Access Compliance Report

Public Rights-of-Way

Intersection ID: 13147	Main Street: GORDON_ST	Cross Street: PECAN_AV	Location: SE
ADA ID: 269D628BB9F5	Ramp Type: Perp	Initial Pass/Fail: Fail	Overall Compliance: No
		Severity Score: 25

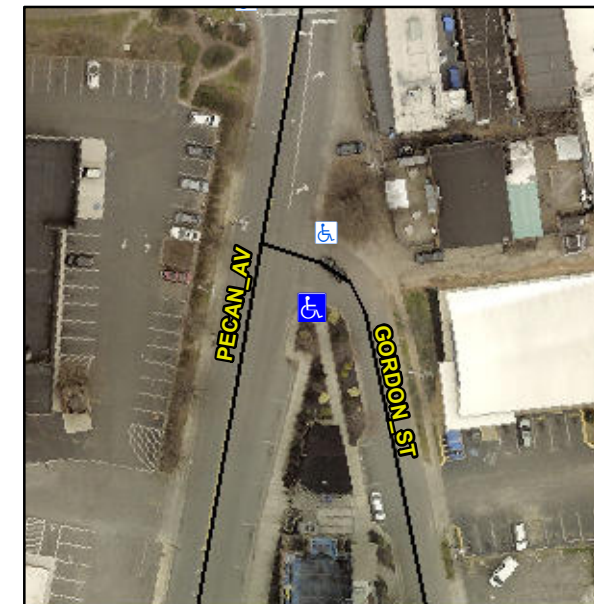
R304.2.2, R304.5.3

Compliance	Description	Data	Compliance	Description	Data
N/A	Ramp Length (in)	65.0	No	Ramp Slope (%)	8.5
Yes	Ramp Width (in)	48.0	No	Ramp XSlope (%)	5.8
N/A	Flare Type LT	N/A	N/A	Flare Type RT	N/A
N/A	Flare Slope LT (%)	N/A	N/A	Flare Slope RT (%)	N/A
N/A	Flare Traversable LT?	N/A	N/A	Flare Traversable RT?	N/A
N/A	Landing Length (in)	N/A	N/A	DWS Provided?	N/A
N/A	Landing Width (in)	N/A	N/A	DWS Contrast?	N/A
N/A	Landing Slope (%)	N/A	N/A	DWS Length (in)	N/A
N/A	Landing X Slope (%)	N/A	N/A	DWS Full Width?	N/A
N/A	Landing Curb? (Y/N)	N/A	N/A	DWS Offset (in)	N/A
N/A	Shared Landing?	N/A			
N/A	Gutter Ponding?	N/A	N/A	Gutter Slope (%)	N/A
N/A	Gutter Lip Ht (in)	N/A	N/A	Gutter X Slope (%)	N/A
N/A	Painted X Walk1?	No	N/A	Painted X Walk2?	N/A
	X Walk 1 Direction	To N		X Walk 2 Direction	N/A
N/A	X Walk 1 Width (in)	N/A	N/A	X Walk 2 Width (in)	N/A
	X Walk 1 Slope (%)	0.2		X Walk 2 Slope (%)	N/A
	X Walk 1 X Slope (%)	7.4		X Walk 2 X Slope (%)	N/A

Remove & Replace Entire Ramp.
